STATE OF NORTH CAROLINA
DEPARTMENT OF TRANSPORTATION

SUBJECT: Request for Modification of the Phased Section 404 Individual Permit and Section 401 Individual Water Quality Certification, Neuse River Riparian Buffer Authorization for the construction of the Triangle Expressway Southeast Extension from NC-55 Bypass in Apex to I-40, Wake and Johnston Counties. TIP Nos.: R-2721, R-2828, and R-2829. Federal Aid Project No. 0540047.

PERMIT DRAWING
SHEET 1 OF 112

WETLAND AND SURFACE
WATER IMPACTS PERMIT

PERMIT DRAWING
SHEET 31 OF 112

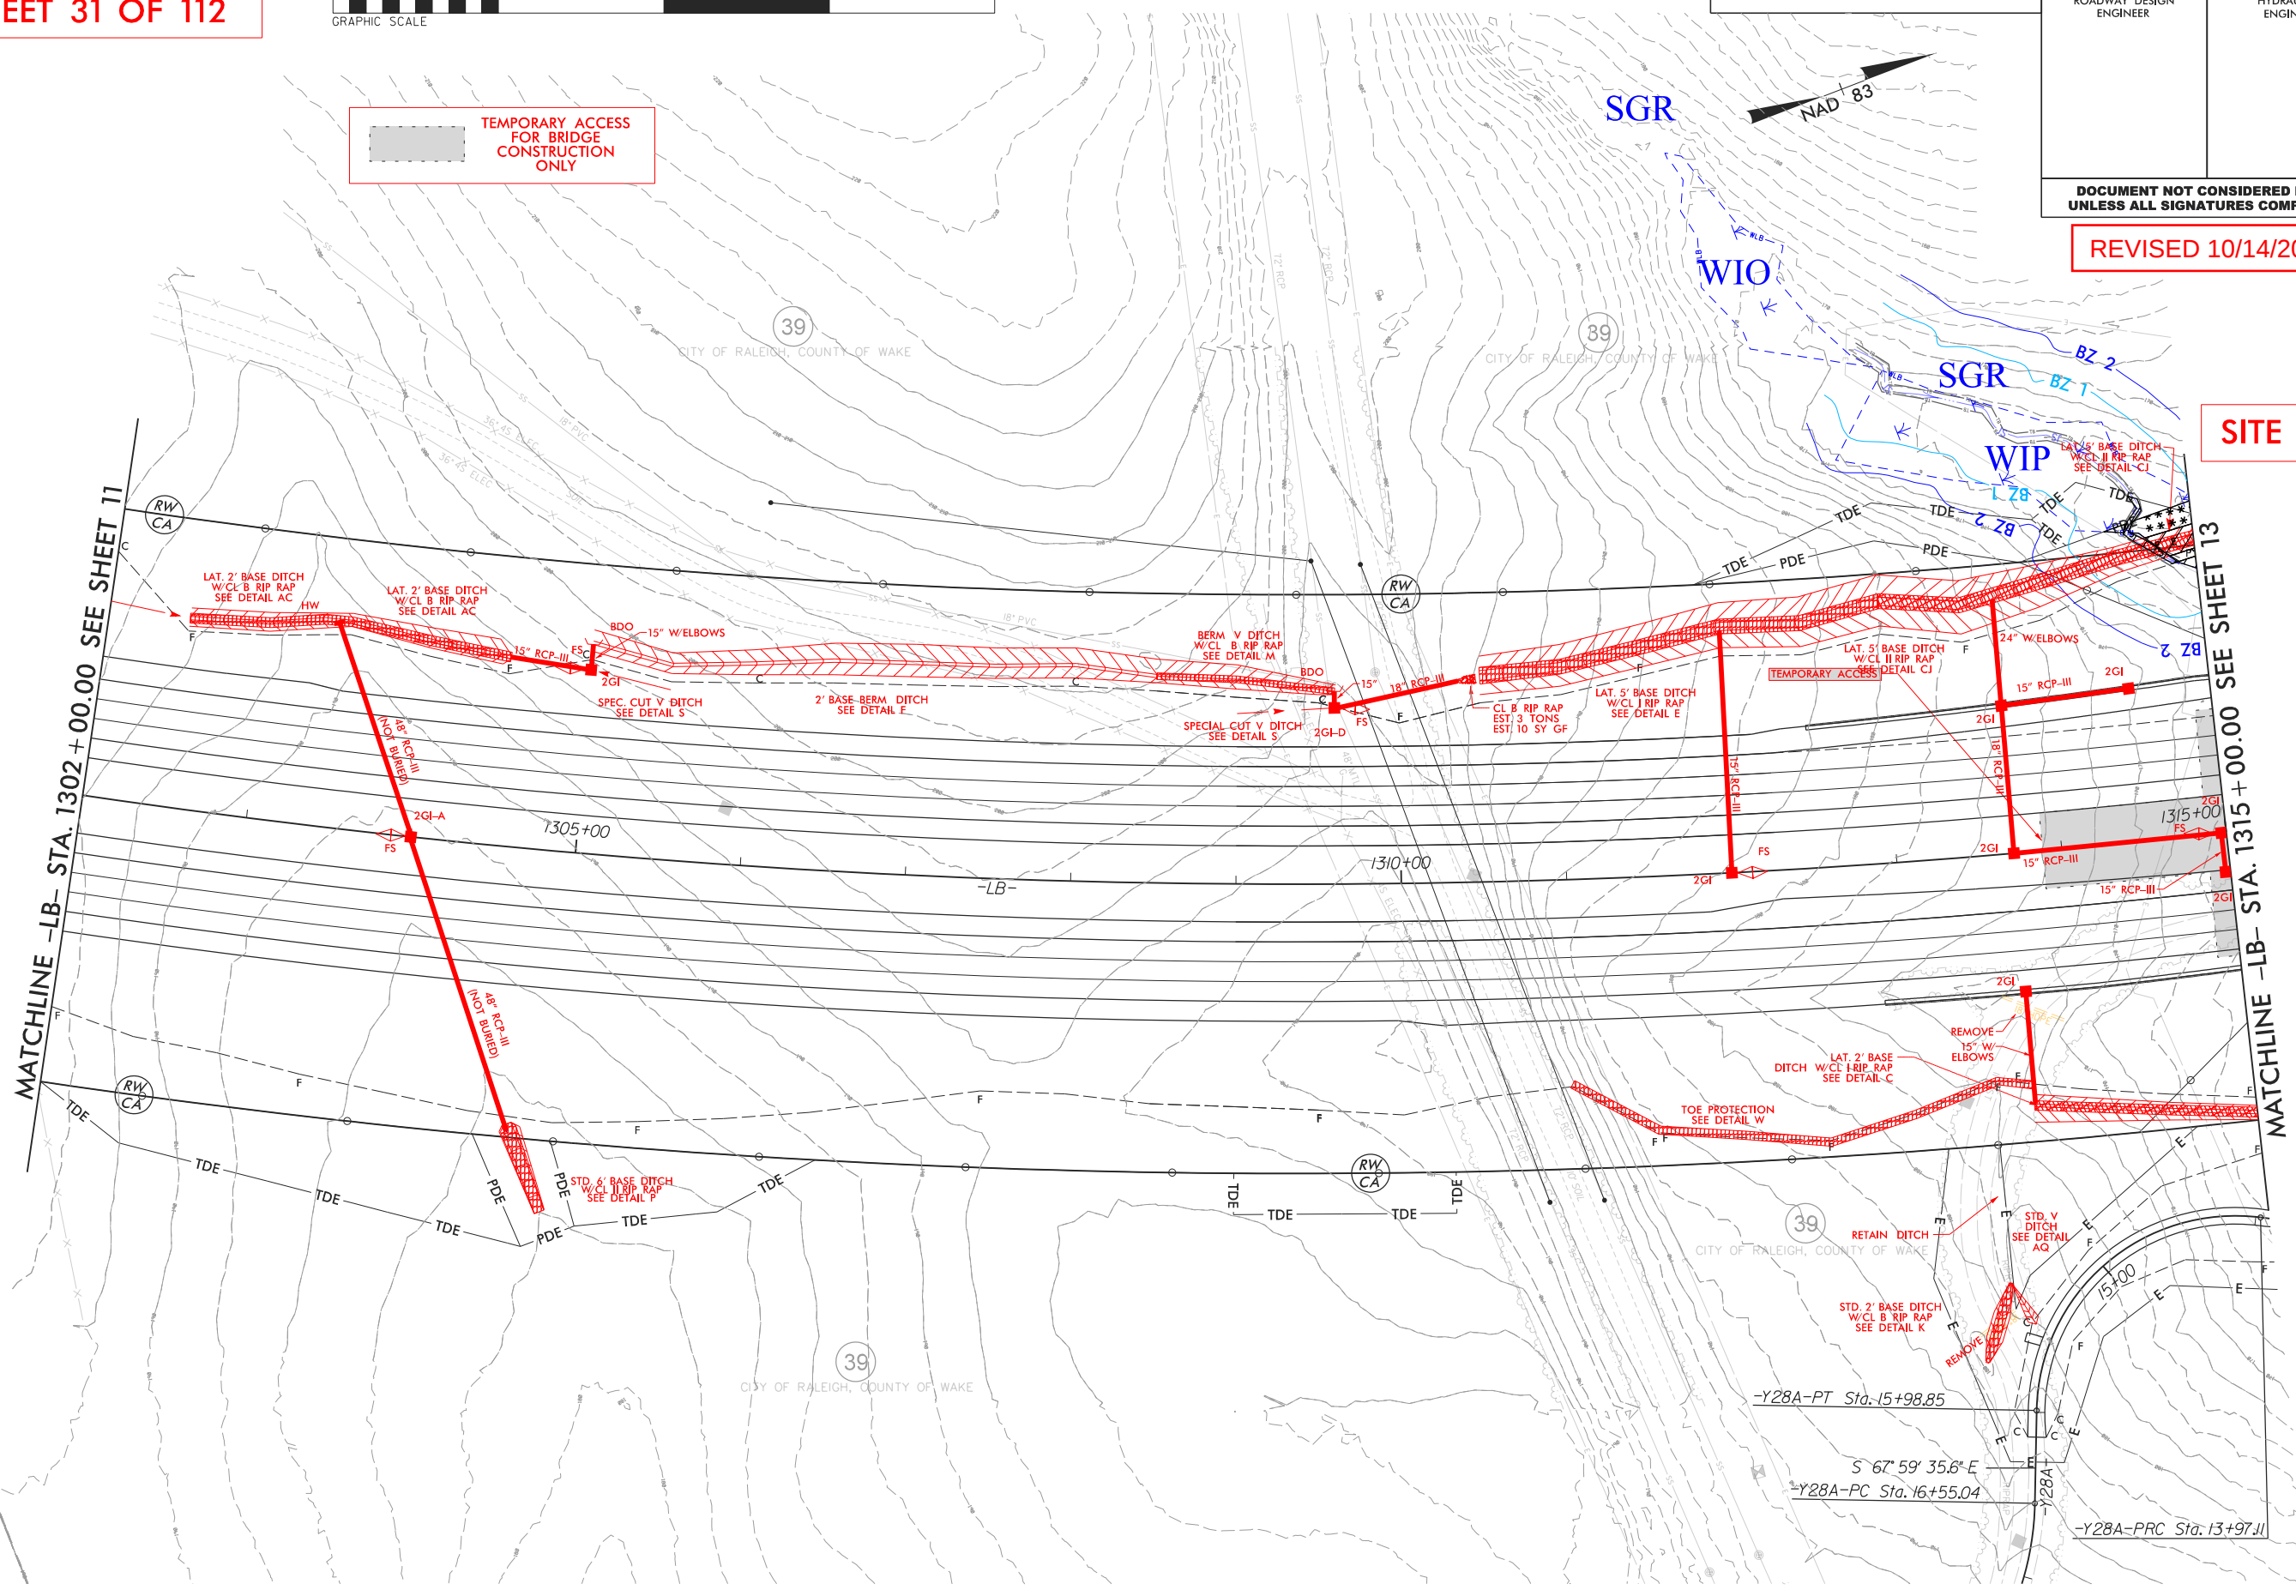
Site 14: WIP and SGR

- Fill in Wetland: 0.036 ac (previously 0 – increase of 0.036 ac)
- Excavation in Wetland: 0.021 ac (previously 0.002 – increase of 0.019 ac)
- Mechanized Clearing in Wetland: 0.030 ac (previously 0.011 – increase of 0.019 ac)
- Permanent Surface Water Impacts: 500 lf (previously 442 – increase of 58 lf)
- Buffer Zone 1 Impacts: 27,754 sq ft (previously 24,910 sq ft – increase of 2,844 sq ft)
 - Wetlands in Zone 1 (WIP): 1,611 sq ft (previously 40 sq ft – increase of 1,571 sq ft)
- Buffer Zone 2 Impacts: 18,077 sq ft (previously 16,255 sq ft – increase of 1,822 sq ft)
 - Wetlands in Zone 2 (WIP): 1,280 sq ft (previously 156 sq ft – increase of 1,124 sq ft)

Permit Site 14 has increased impacts due to the lateral base ditch going around the end of the permanent bridge fill. These impacts were reduced to the greatest extent possible. Steeper slopes are not possible given the topography of the area. A retaining wall option was explored, but it did not reduce impacts to the jurisdictional resources in this area because regardless of steepening the bridge abutment fill slope and bringing the lateral base ditch closer to the NC 540 alignment, the flow in stream SGR would still have to be intercepted and conveyed through the lateral base ditch to the Neuse River, resulting in similar impacts. During the early planning phases of the project, the design team thoroughly explored potential realignment options, including the bank excavation approach outlined in Alternative 6 as a possible mitigation measure. After careful review, it was determined that excavation would likely create additional impacts to the City of Raleigh's sewer line, which already presents challenges due to a critical crossing and the limited space around existing manholes.

SITE 14 & 15
ENLARGEMENT

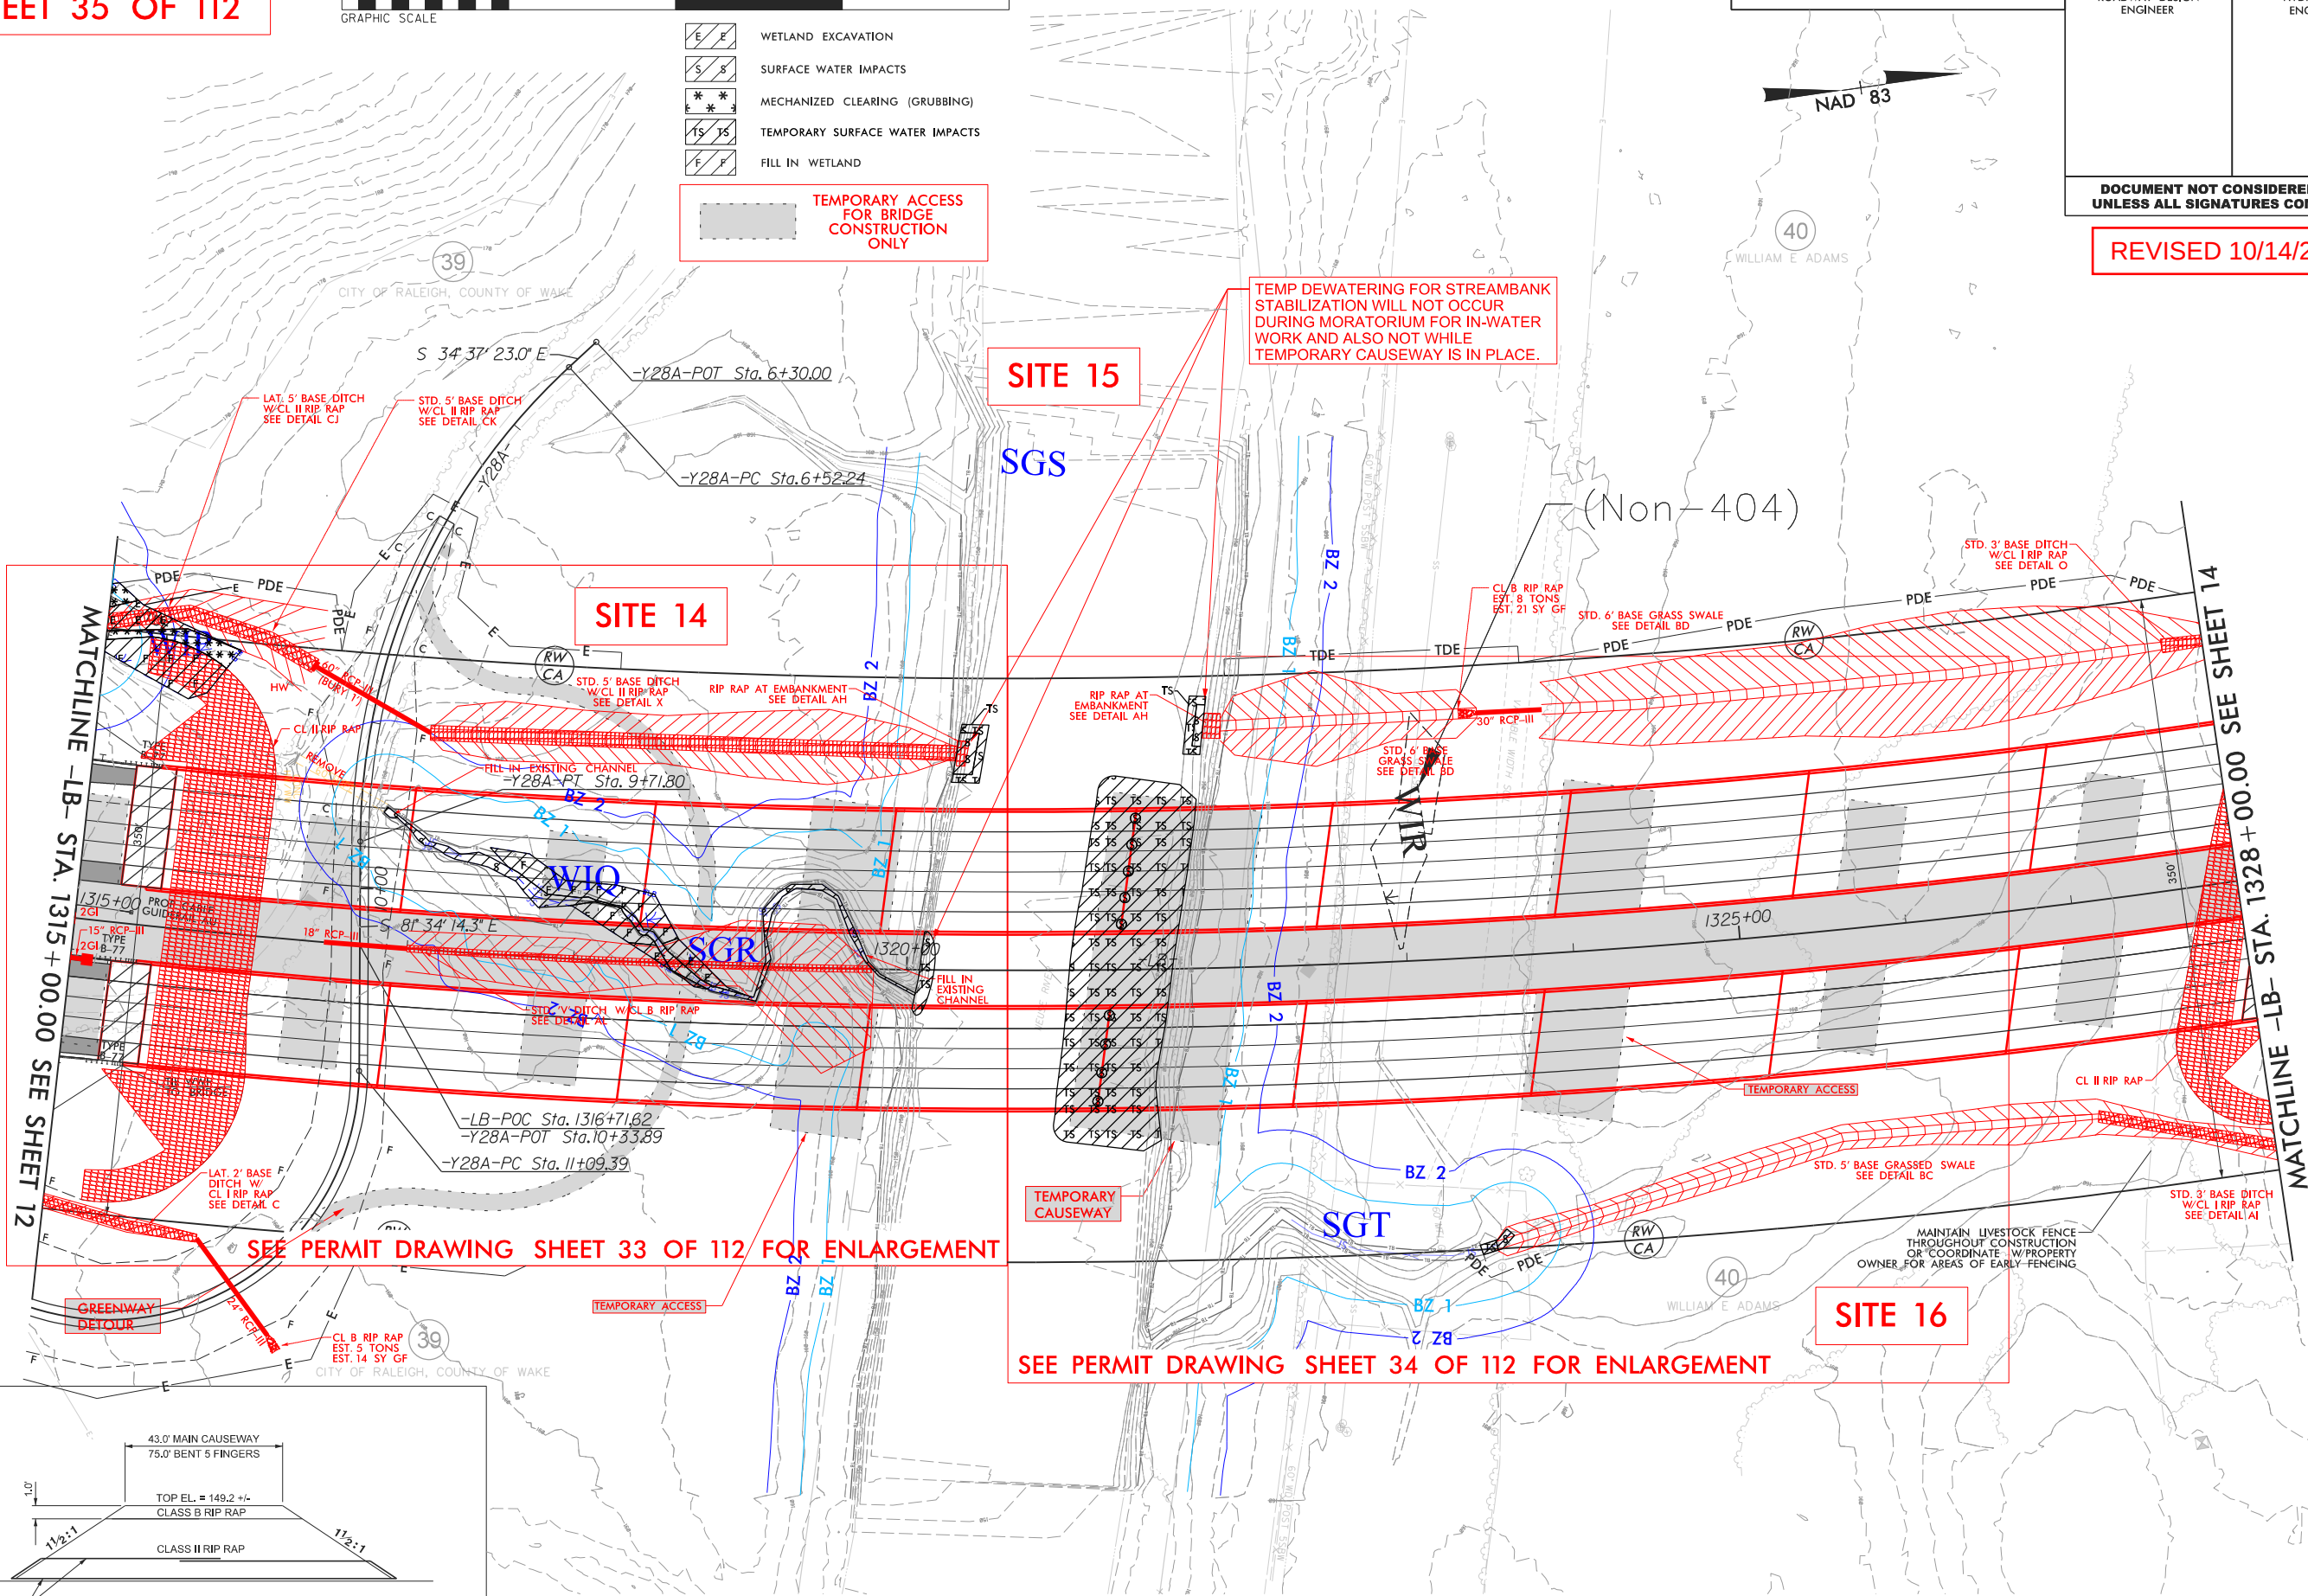
Site 15: Neuse River (-LB- 1319+95 TO 1321+83 M - BANK STABILIZATION)

- Permanent Stream Impact: 51 lf (previously 76 lf – decrease of 25 lf)
- Temporary Stream Impact: 73 lf (previously 108 lf – decrease of 35 lf)

The elimination of a lateral base ditch results in a reduction of bank stabilization impacts to the Neuse River where the ditch previously tied in.
